**Amendments to the Drawings**

Docket Appl'n No.: 09/628,614  
Title: Method and Apparatus for Storage and  
Inventors: John Christopher Brock, et al.  
Annotated Marked-Up Drawings

FIG. 5

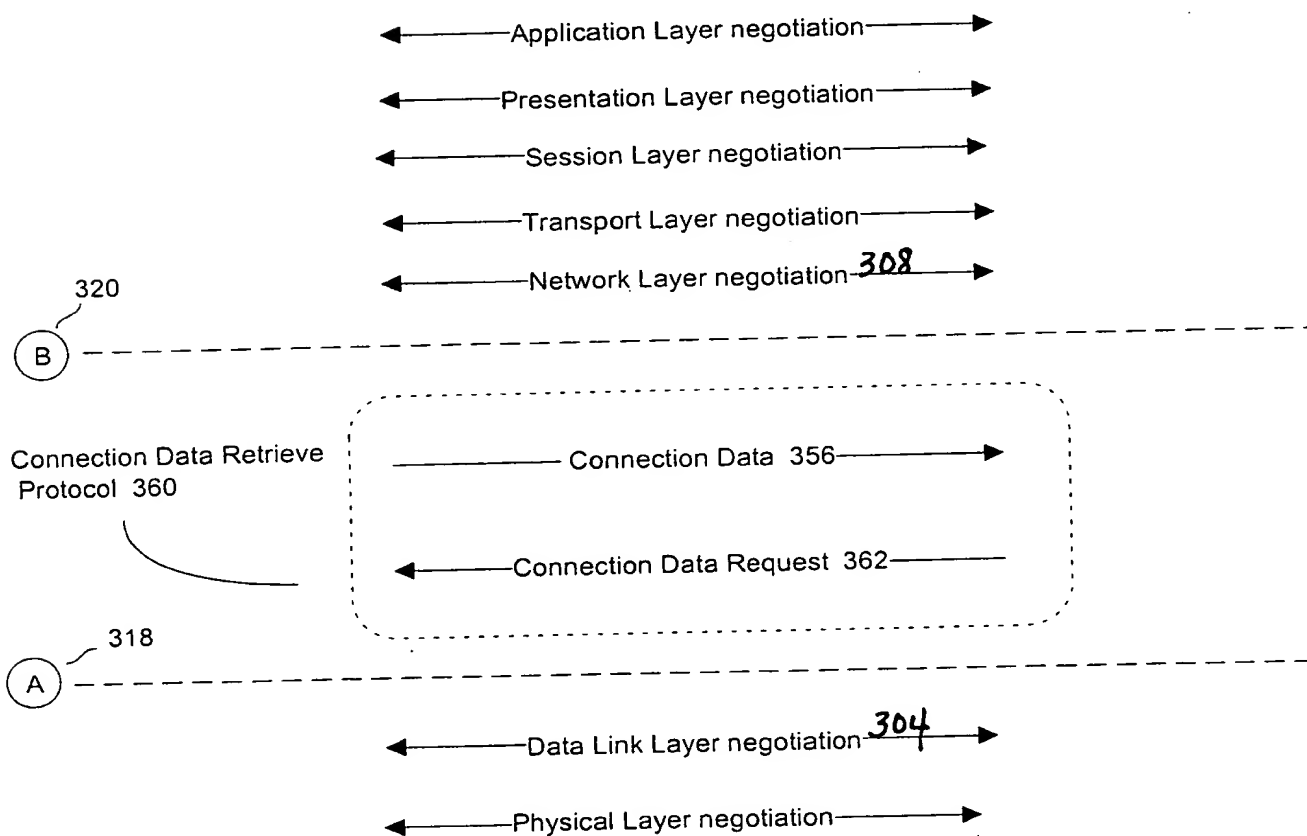
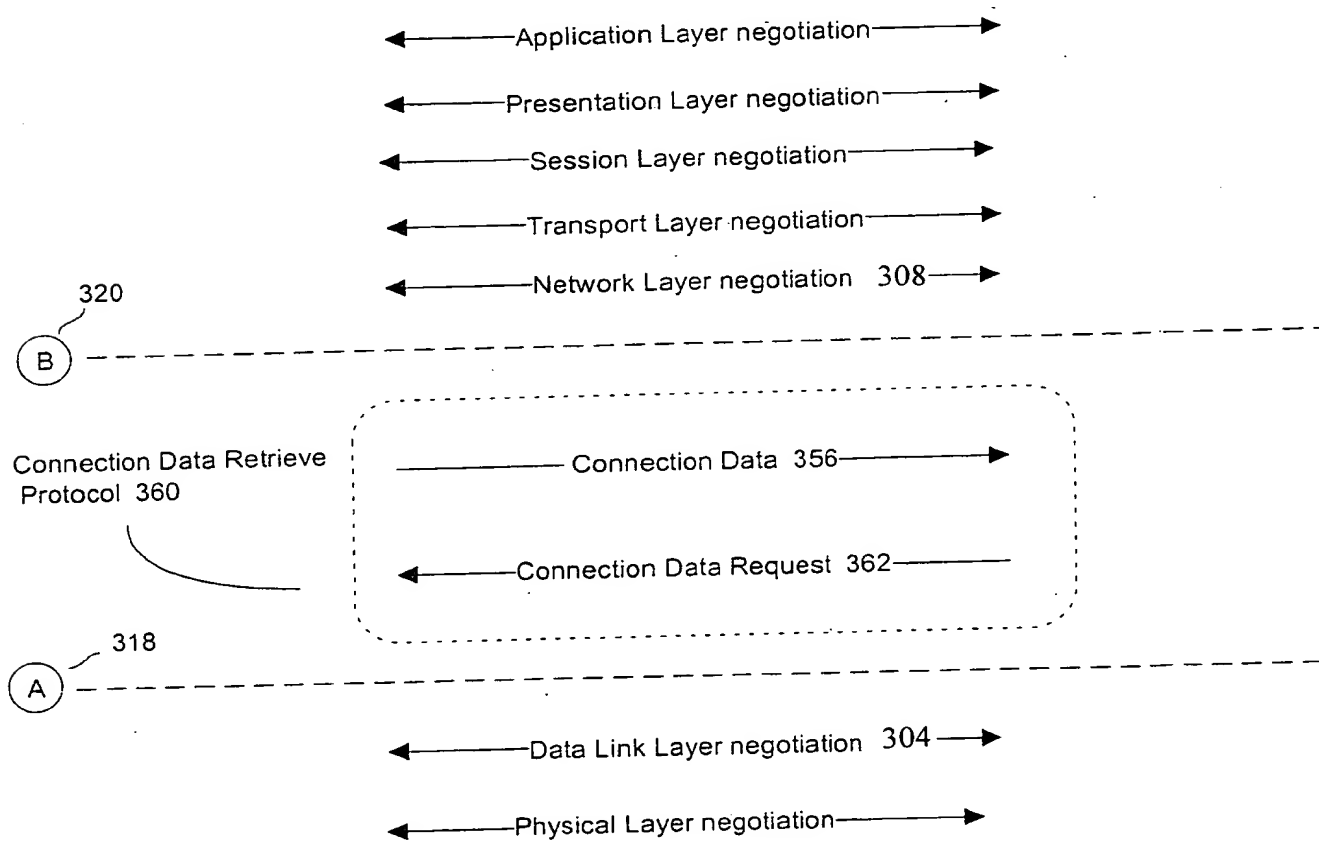
FIG. 5 is amended to add reference signs 304, 308 referred to in the specification. FIGs. 6 and 7 are amended to correct misspelled wording "Recieve". No new matter is added.
